Eastern Regional Power Committee

Sub: Minutes of the 140th PCC meeting held on 24.10.2024

MINUTES OF 140th PROTECTION COORDINATION SUB-COMMITTEE MEETING TO BE HELD ON 24.10.2024 AT 10:30 HRS THROUGH MS TEAMS

Event: 400kV Bus-2 tripped on Bus bar Protection & 400KV Talcher-2 during mal-operation of 40789A.

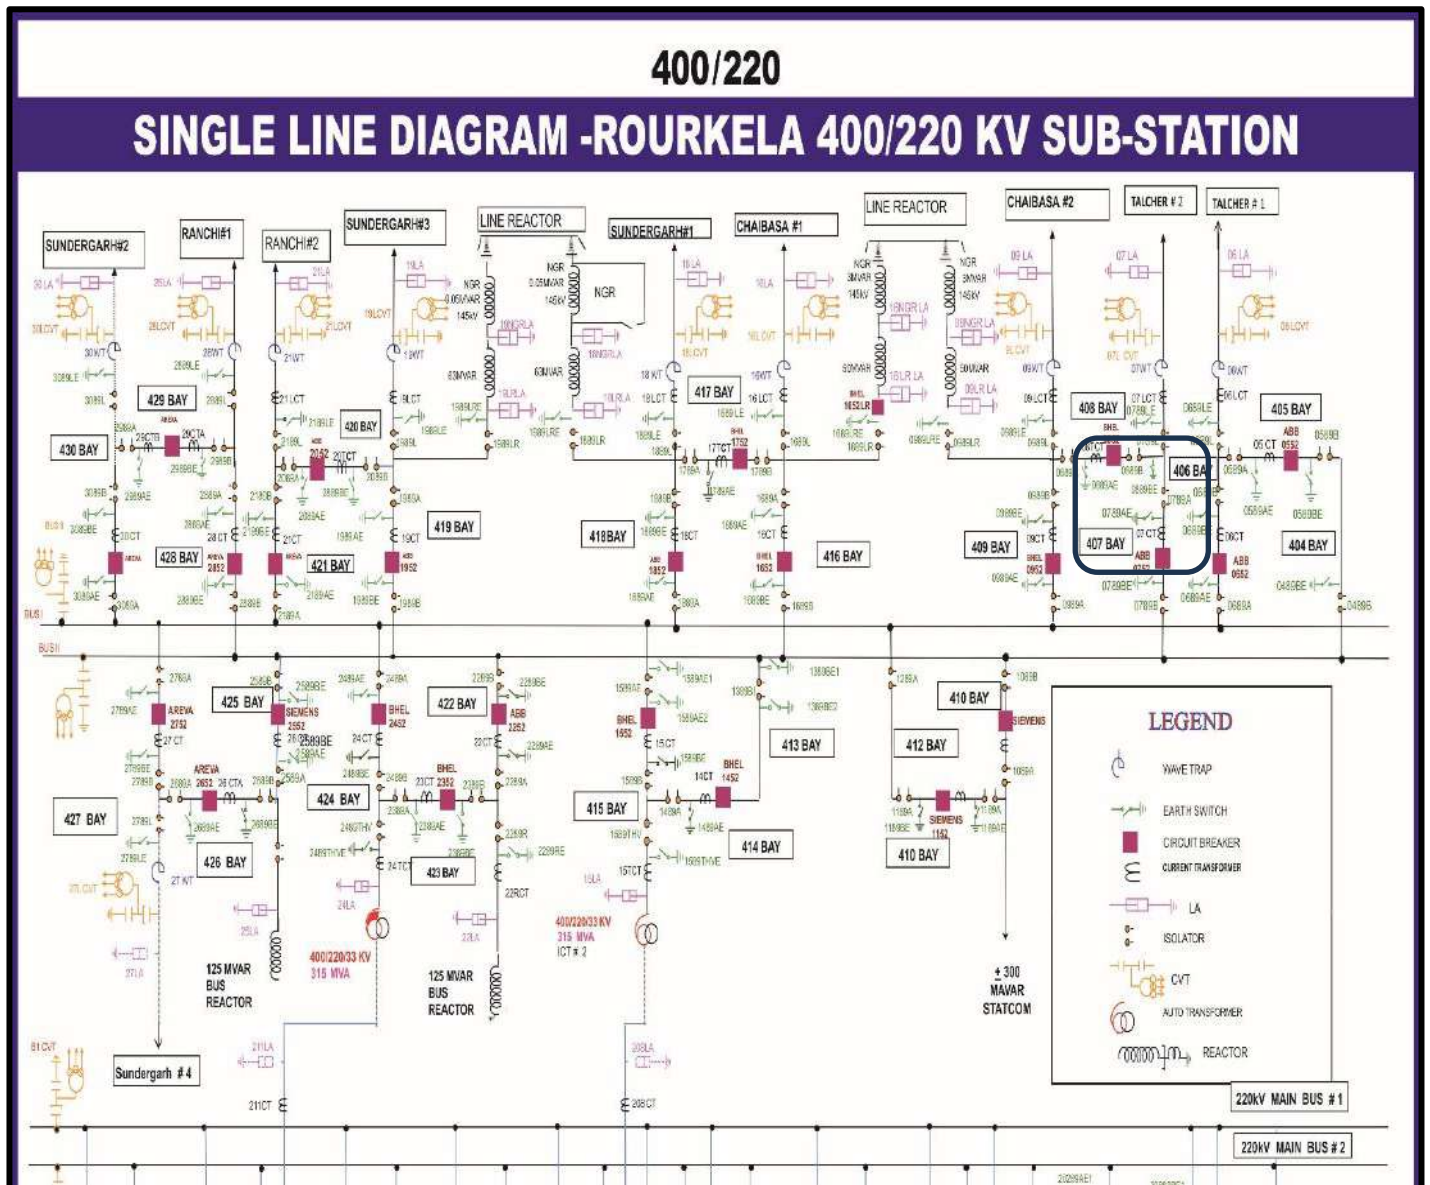
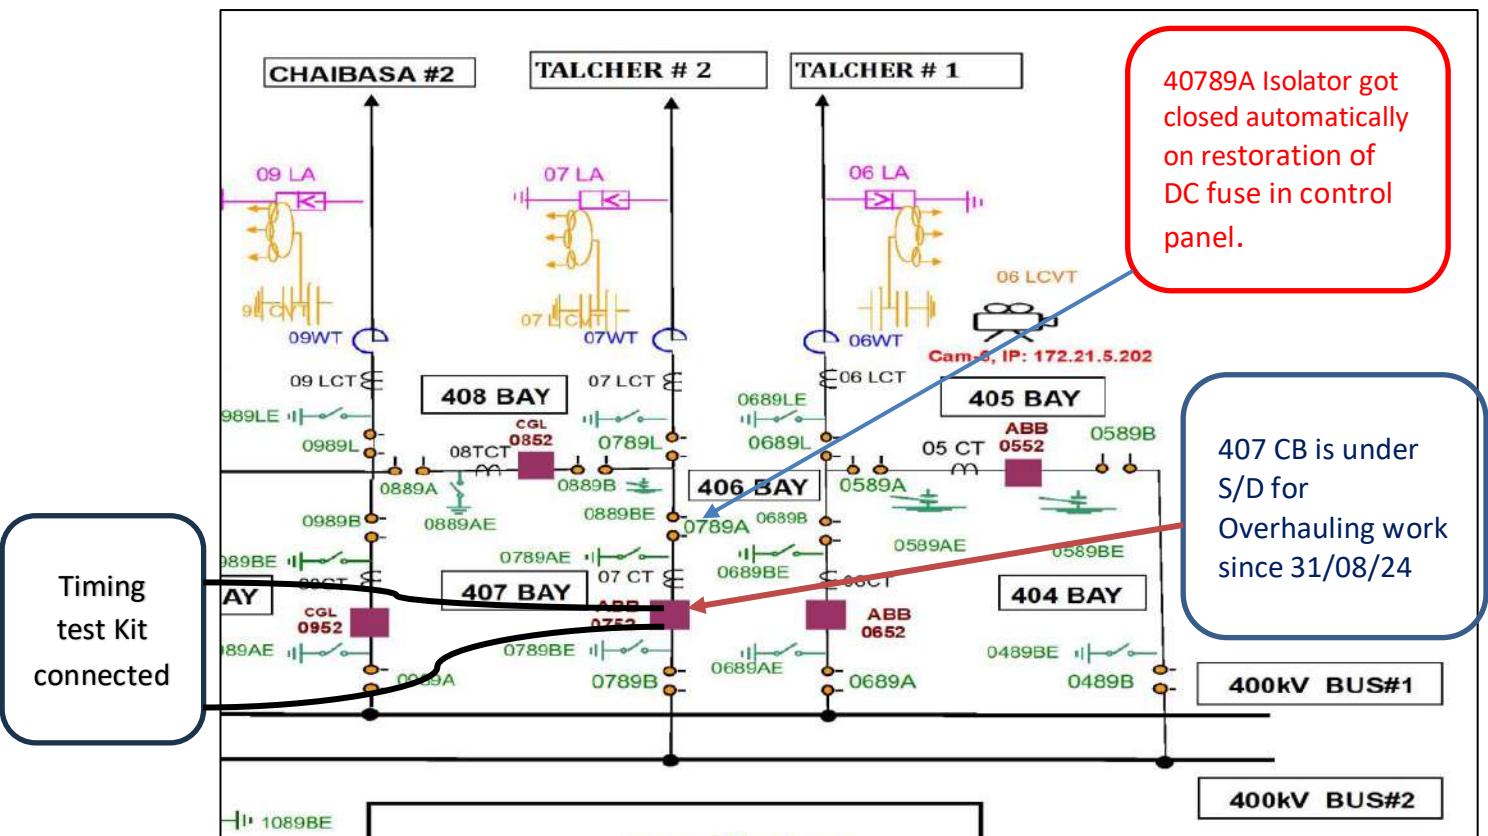
1. **15:45:37:620** Talcher-2 main bay isolator (40789A) closed
2. **15:45:40:817** M1 BB Relay of 400KV Bus-2 operated.
3. **15:45:40:819** M2 BB Relay of 400KV Bus-2 operated.
4. **15:45:40:864** All feeders connected to Bus-2 got tripped
5. **15:45:41:135** Talcher-2 (407 bay) LBB operated & tripped respective Tie CB (408 CB) and sent DT to other end.

1. 400KV Talcher-2 main bay (407) is under S/D for CB Drive Overhauling work and Modification of Mechanical gang to Electrical gang operation of 40789A isolator since 31.08.24.

2. On 05.09.24, DCRM & Timing testing of CB are completed, and cables were about to be opened.
3. Meanwhile, Isolator DC supply fuse in control panel at C/R was connected to check the DC supply up to isolator MOM box. Immediately 40789A isolator automatically closed.
4. This resulted in 400KV Bus-2 fault through test kits and resulted in BB protection operation and tripping of all CBs connected to Bus-2.
5. After tripping, the cause of extension of DC for close operation is checked and found that TNC switch of respective isolator in control panel is extending the DC to close circuit. The same was replaced.

1. DC & AC supply in Isolator MOM boxes should be kept off till all works on CB are completed and T&P are removed.

2. DC supply from Control panel to 40789A Isolator should not be extended till all works on CB are completed.

Analysis of Fault occurred on 05.09.2024 at 15:43 Hrs

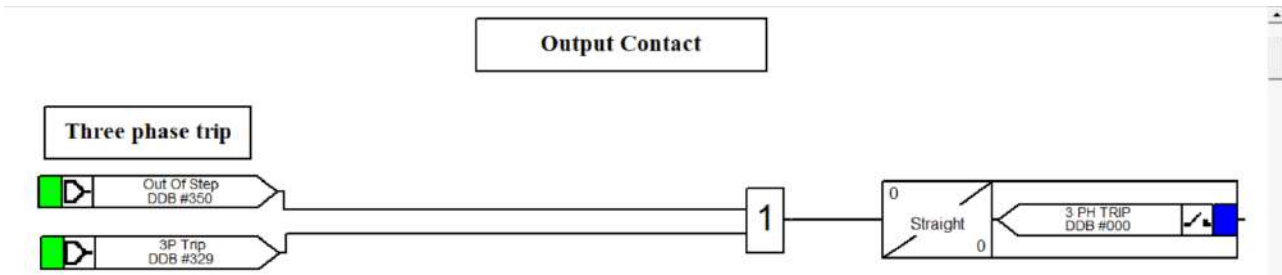
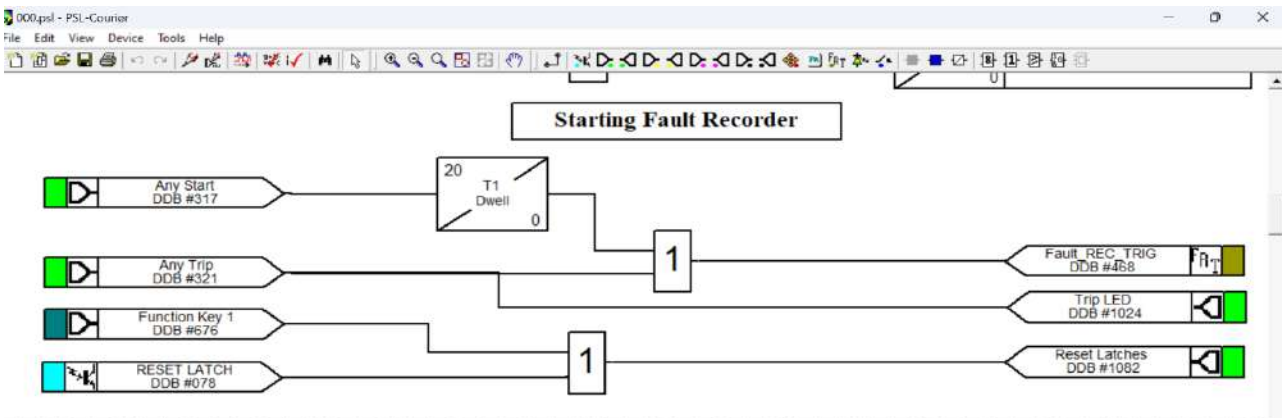
Both circuit 1 & circuit 2 tripped on out of step as per the OUT OF STEP node directly configured with **Three pole trip** contact in our configuration.

In Micom P444 relay we have configured Fault Record Triggering by Any Trip Node. As there is no internal logic of OUT OF STEP function configured with any trip function. So no DR triggered in Micom relays of both the circuit.
